ATTACHMENT 1

A. DESCRIPTION OF THE TECHNICAL SPECIFICATION AMENDMENT REQUEST

The proposed amendment changes the Shutdown Margin versus Cold Leg Temperature curve as set forth in Technical Specification (T.S.) 3.1.1.2. The change is to the Hot Zero Power endpoint. The change is from  $6.0\% \Delta\rho$  to  $6.5\% \Delta\rho$ .

FIGURE 3.1 - IA

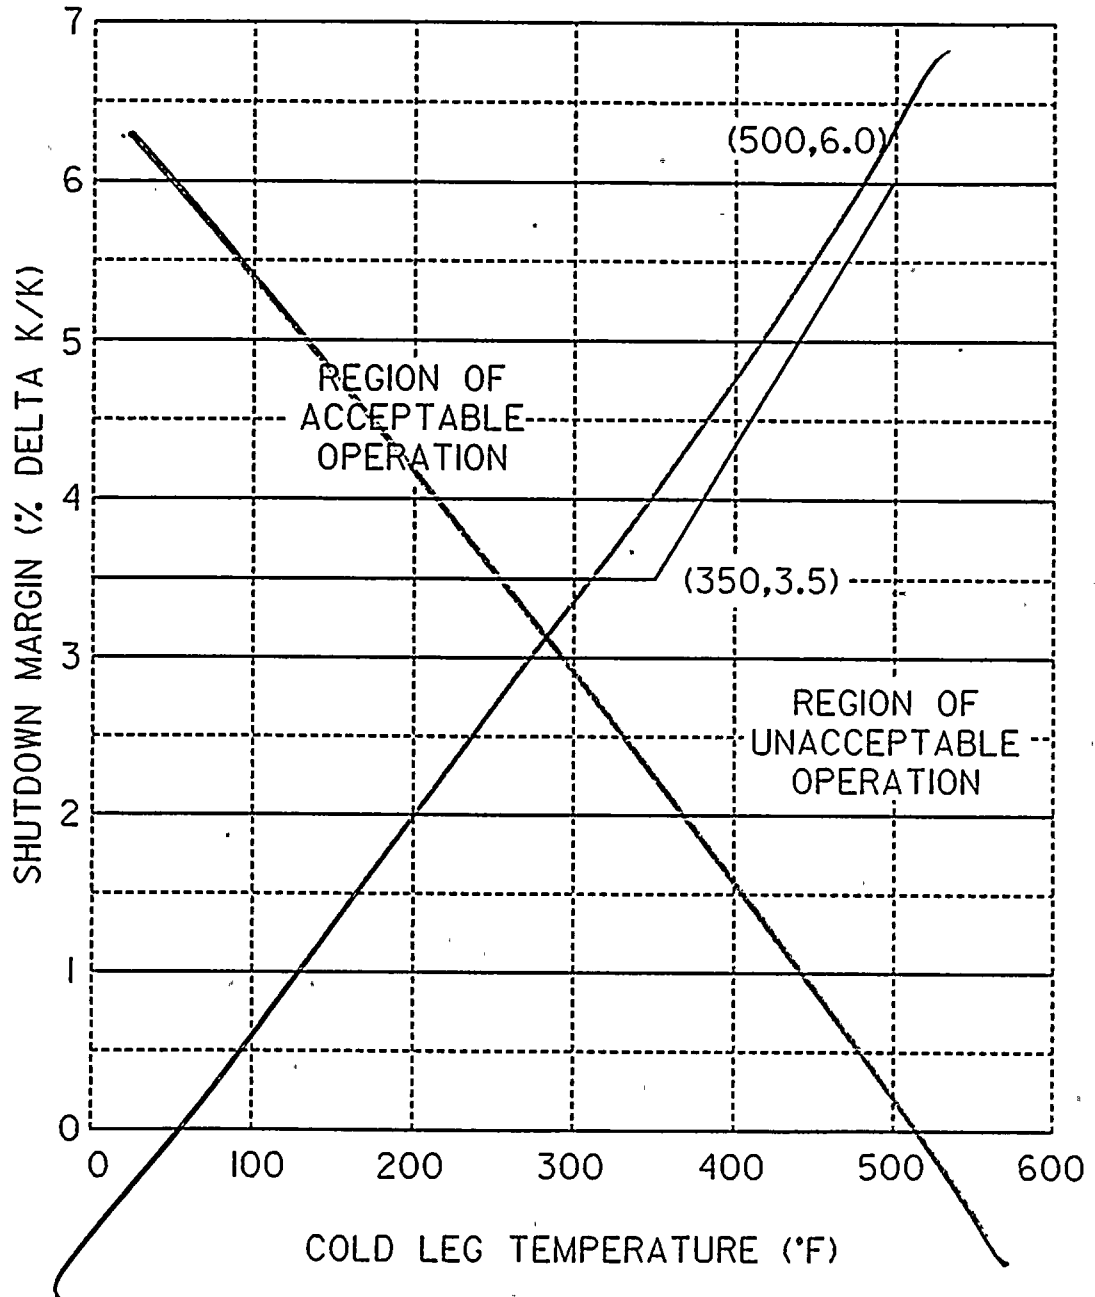
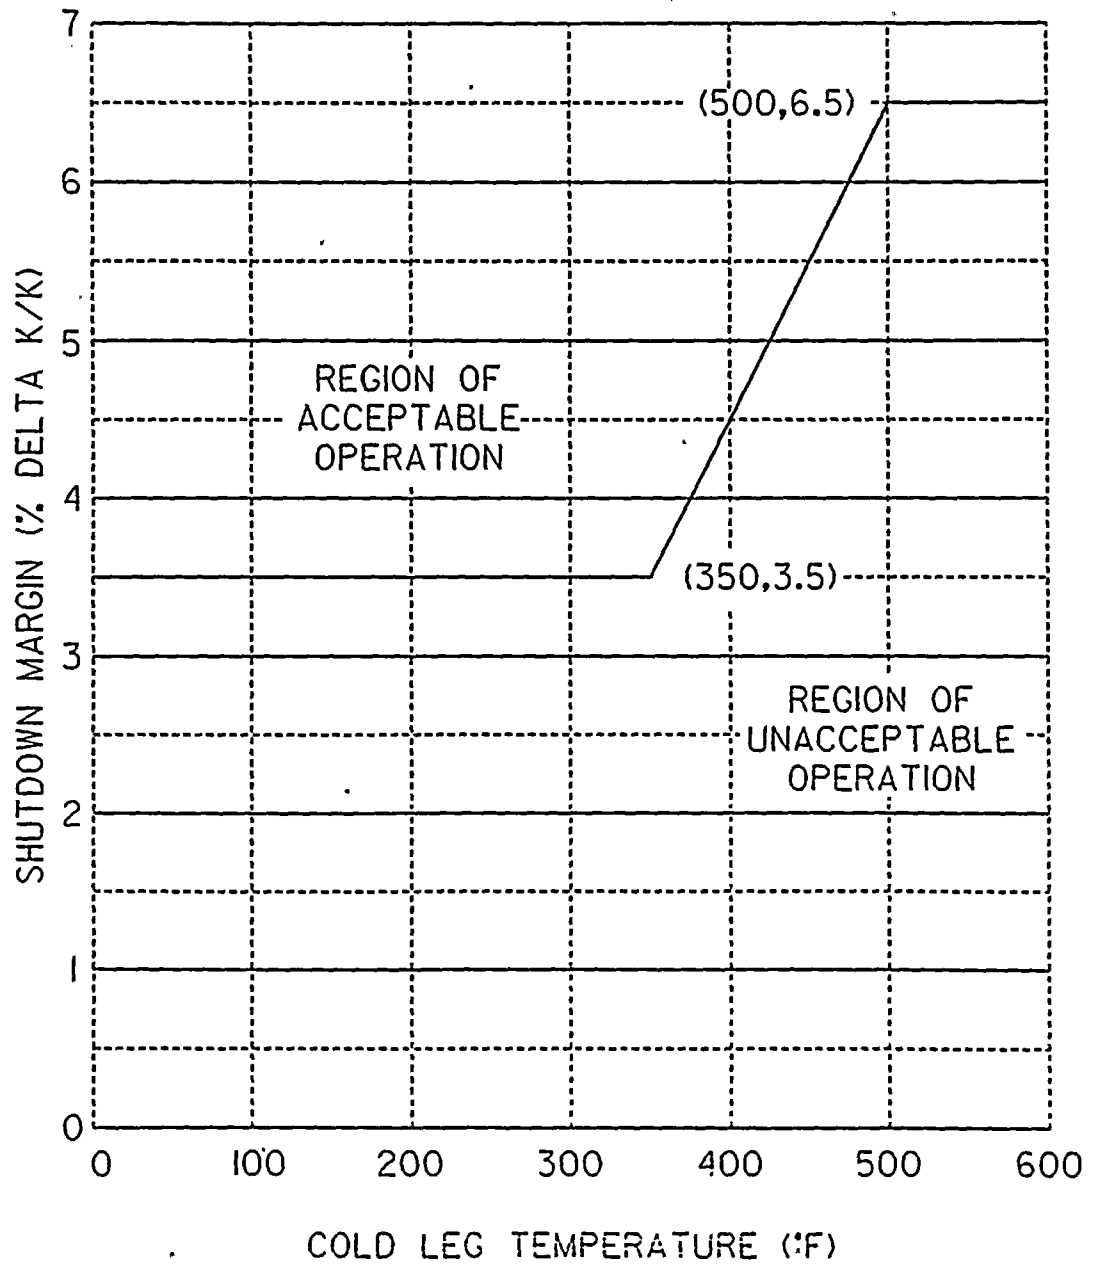
Due to the design of Cycle 2, the Cycle 2 moderator temperature reactivity insertion is more adverse than Cycle 1 during a postulated steam line break. Because of the more adverse cooldown reactivity insertion for Cycle 2, the Shutdown Margin is required to be increased from  $6\% \Delta\rho$  to  $6.5\% \Delta\rho$  at zero power. The increase in margin is required to maintain the operation of Cycle 2 within the safety analysis.

FIGURE 3.1-1  
ALLOWABLE MIC MODES 1 AND 2  
PALO VERDE UNIT 2 CYCLE 2

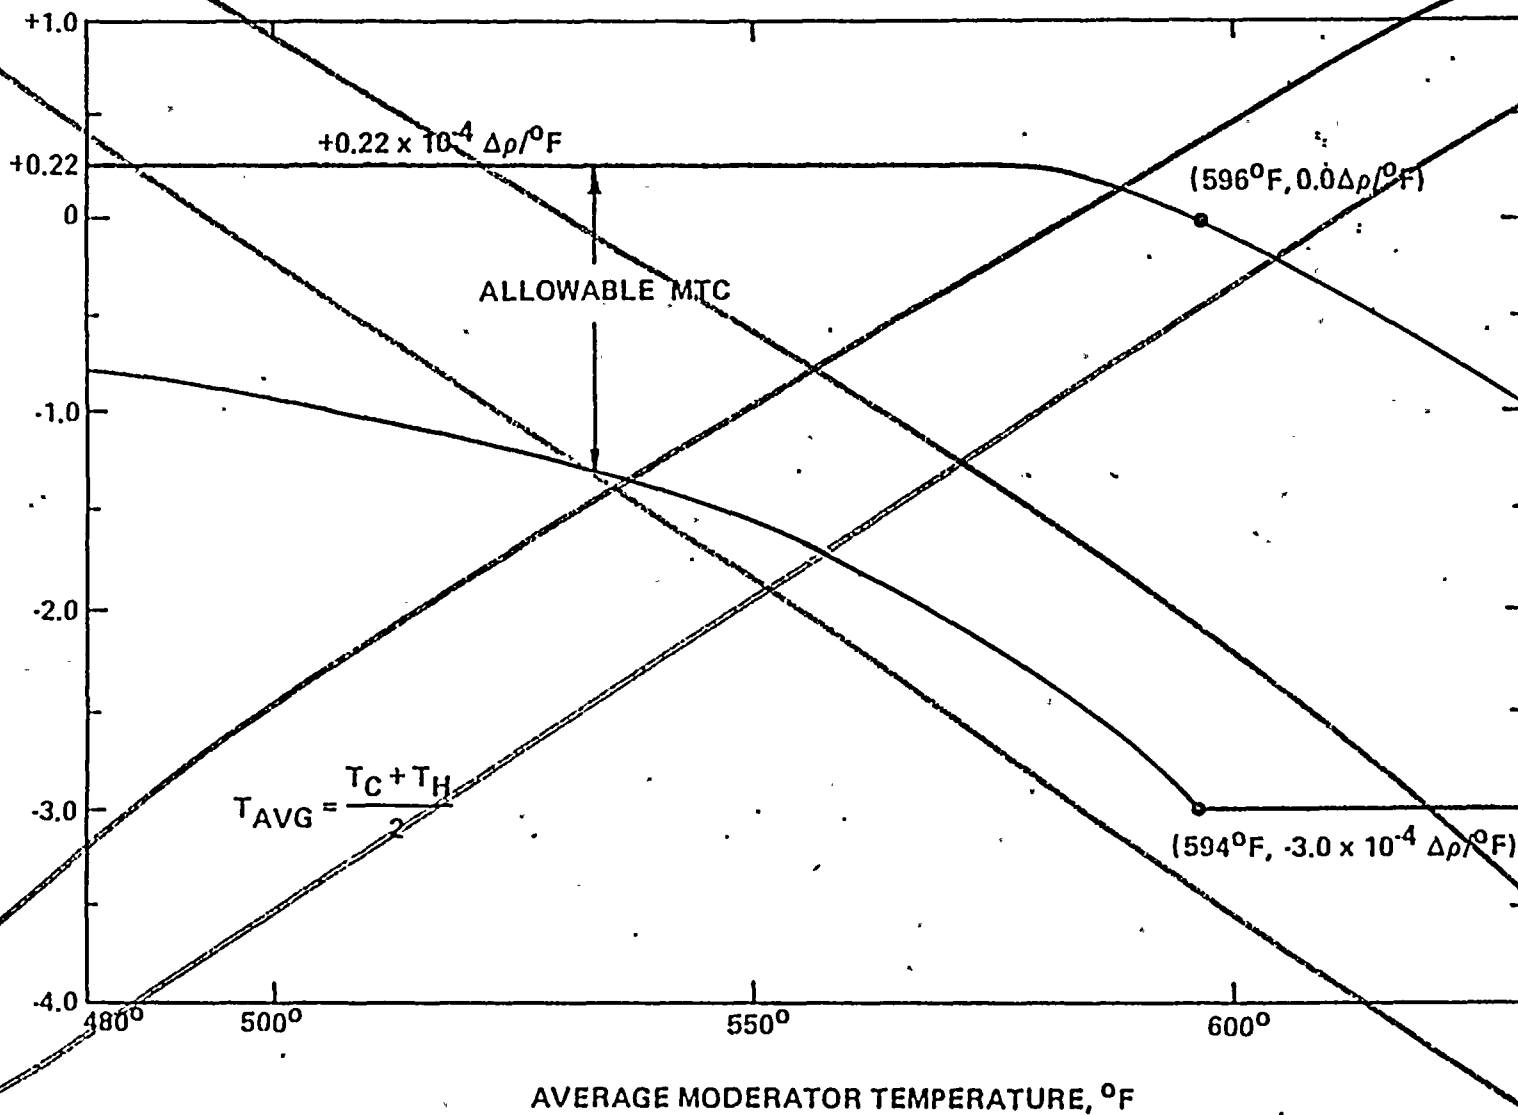
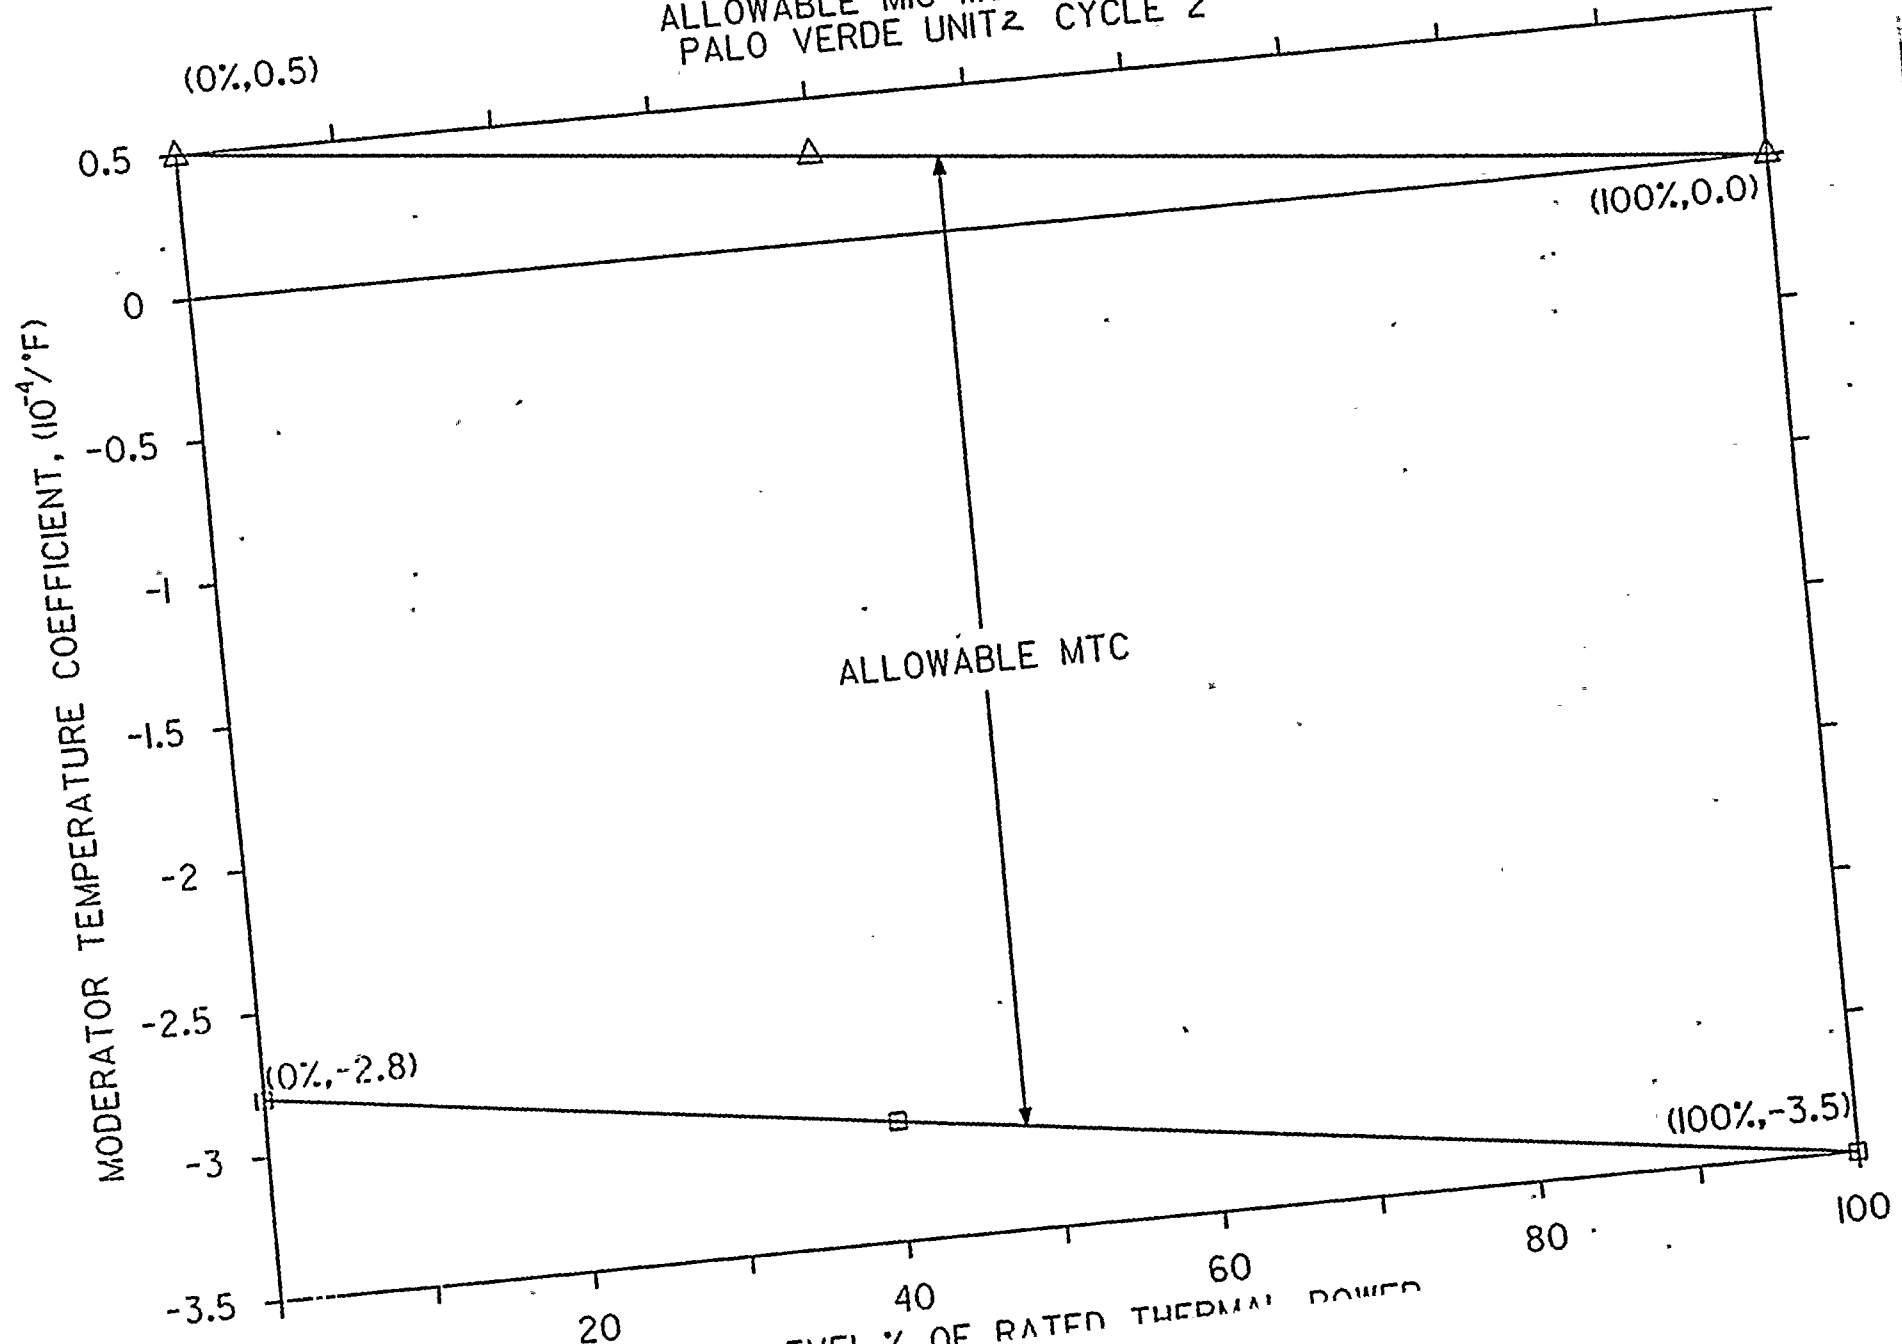
The proposed amendment changes the Moderator Temperature Coefficient (MTC) Figure 3.3-1 as set forth in Technical Specification (T.S.) 3.1.1.3. The changes are two fold. The operating bounds of the MTC are being broadened to accommodate the operation of Cycle 2 and the x axis is being changed to core power level instead of average moderator temperature.

In preparation for future 18 months cycles, the Cycle 2 core physics is such that a change in the MTC operating band will occur. To accommodate operation throughout Cycle 2, the MTC operating band has become more positive because of the increase in fuel enrichment which requires higher boron concentration at beginning of the cycle. As operation into the cycle proceeds, the MTC will become more negative. In addition, the x axis is to be changed to core power level instead of average moderator temperature. By changing the x axis to core power level, the method of calculating the bounding MTC for the most limiting case becomes simplified. Making the MTC a dependent variable of core power only and not of inlet temperature and core power, as the present curve represents, the calculation of the limiting MTC need only be performed once. The present method of manipulating MTC requires performing the analyses several times at various average moderator temperatures to be sure of obtaining the most limiting case but, with the new method, MTC can be calculated once and there is assurance that the most limiting case value is obtained. Both graphs are the results of the same set of codes, only the method of manipulating the data is slightly different.

FIGURE 3.1-2A

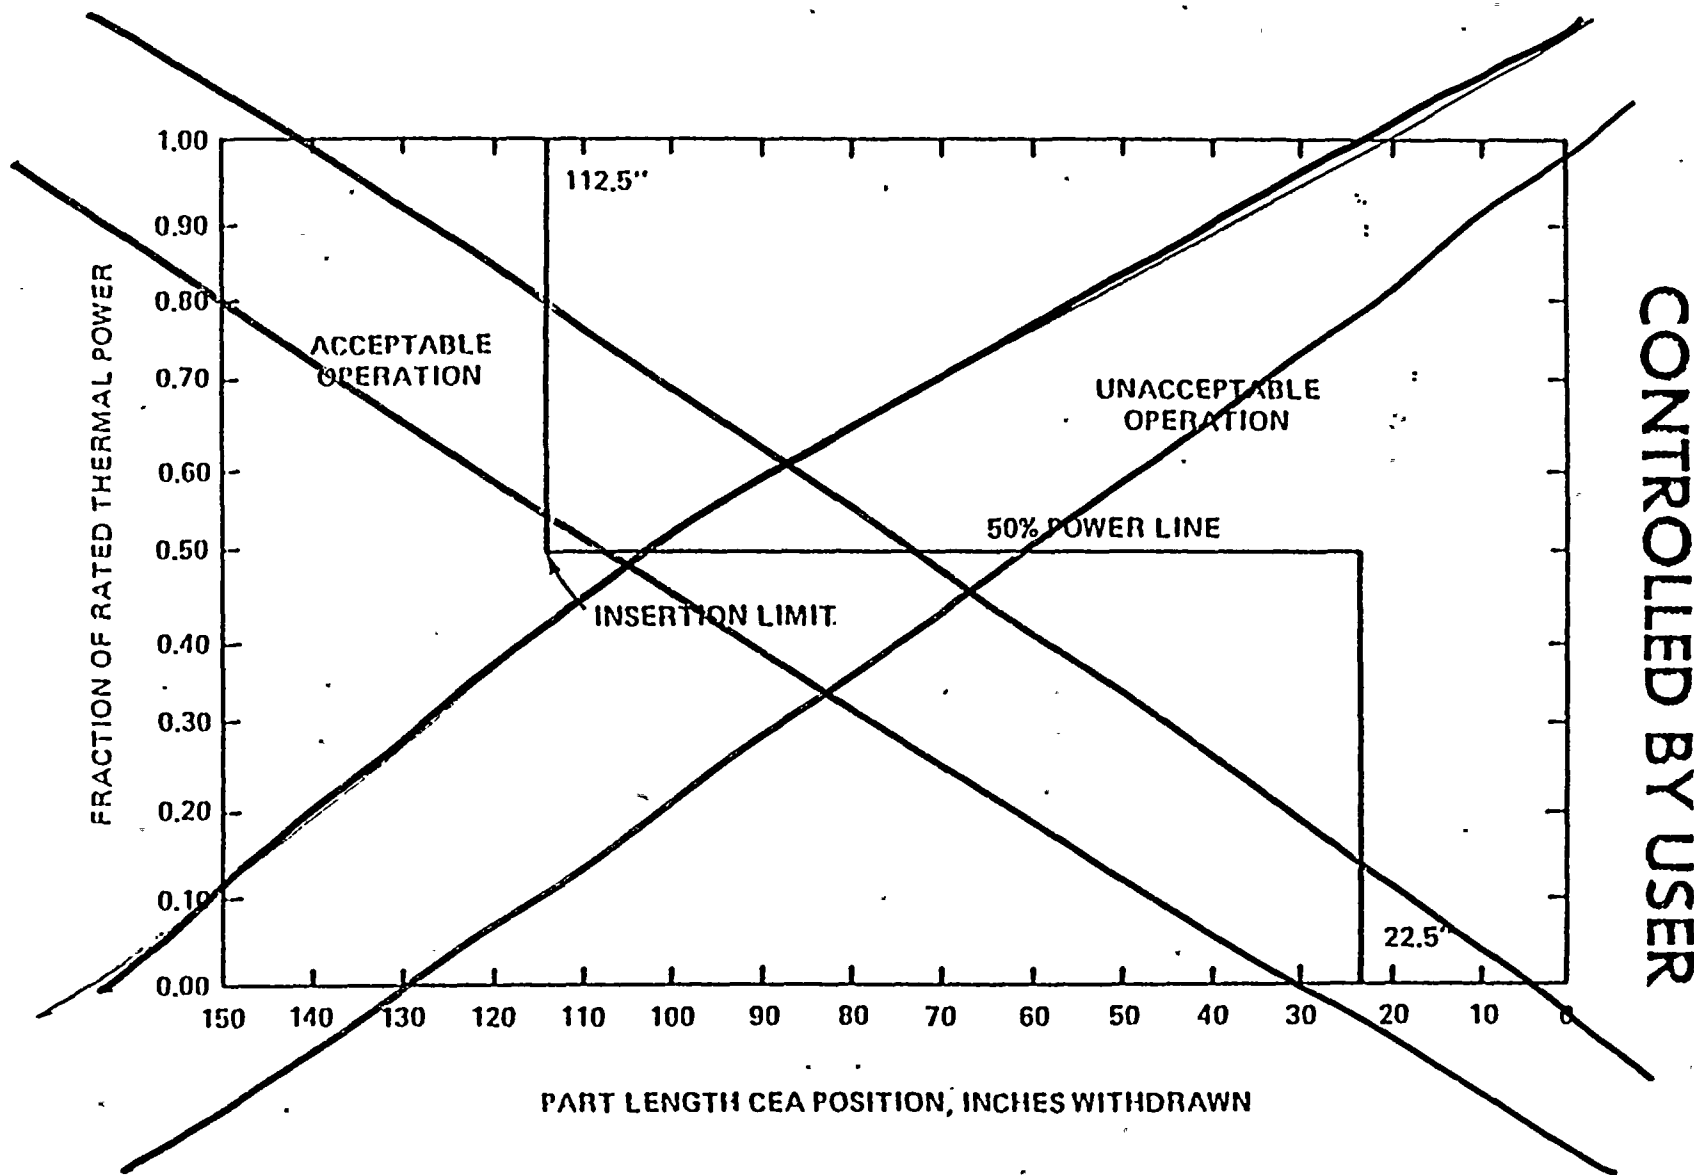
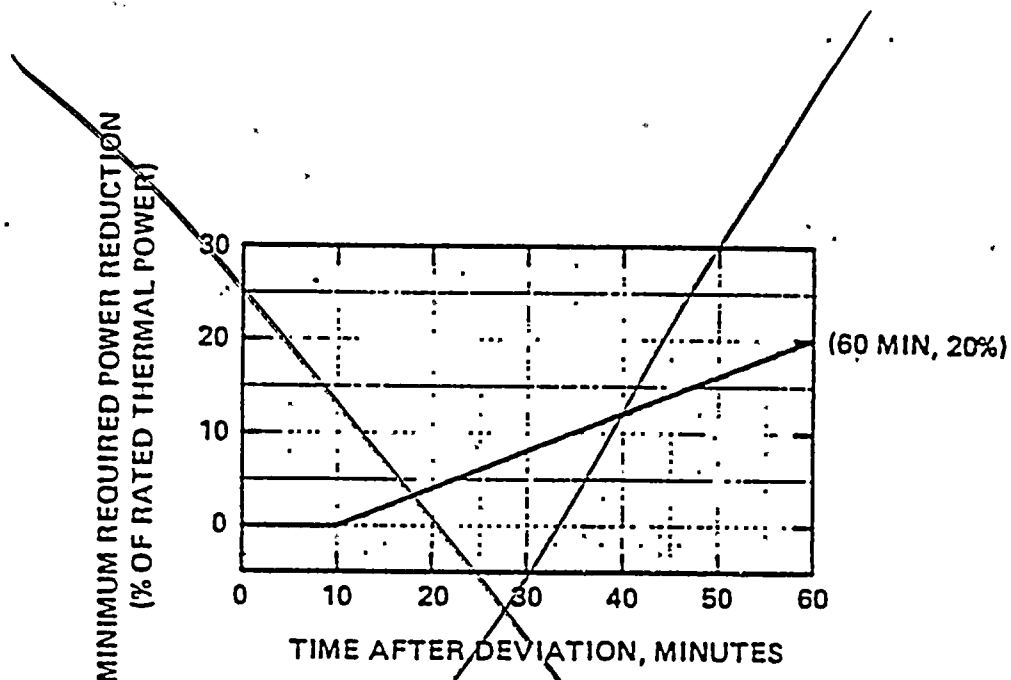
The proposed amendment modifies the CEA position Technical Specifications (T.S.) 3.1.3.1 and 3.1.3.2 by removing direct references of the control of insertion of the Part-length Control Element Assemblies (PLCEA) and creates an additional T.S. that addresses the length of time for insertion and the insertion limit of the PLCEA specifically.

Creating a separate T.S. for addressing operation of the PLCEA would provide an improvement to the potential consequences of a PLCEA drop or slip initiated from an allowable inserted position. It would also add a more explicit Limiting Condition for Operation to clarify the allowable duration for the PLCEA to remain within the defined ranges of axial position.
